SUBJECT: Revised Core Operating Limits Report for Indian Point Unit 3 –
Mid-Cycle Revision
Docket No. 50-286
License No. DPR-64

Indian Point 3 COLR – Mid-Cycle Revision for Cycle 16

3-GRAPH-RPC-16 , Revision: 2

REVISION SUMMARY

Figure 1
Reactor Core Safety Limit – Four Loops in Operation

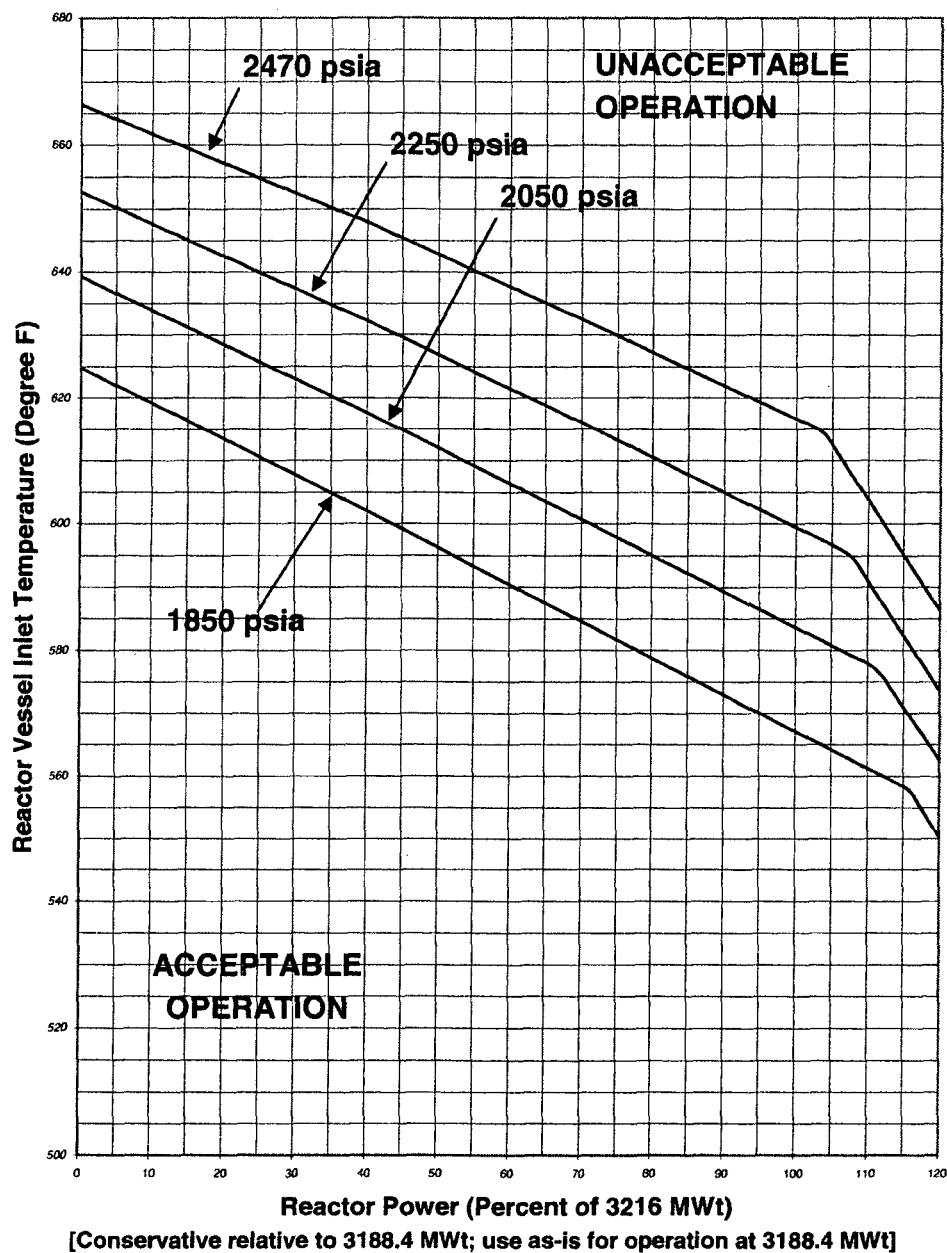
2.1 This revision corrects an editorial error in the COLR. The Indian Point Unit 3 Cycle 16 COLR text for "TS 2.1.1 Reactor Core SLs" has been revised for consistency with "Figure 1 Reactor Core Safety Limit – Four Loops in Operation" in COLR, as well as the Indian Point Unit 3 Technical Specifications. This revision is not considered a significant safety concern. The guidance that was presented in the COLR text would have resulted in a conservative determination of a safety limit being exceeded when applied to the COLR Figure 1 since Reactor Vessel average temperatures would have been compared to limits on Reactor Vessel inlet temperatures.

In MODE 1 and 2, the combination of thermal power level, pressurizer pressure, and Reactor Vessel inlet temperature SHALL not exceed the limits shown in Figure 1. The safety limit is exceeded if the point defined by the combination of Reactor Vessel inlet temperature and power level is at any time above the appropriate pressure line.
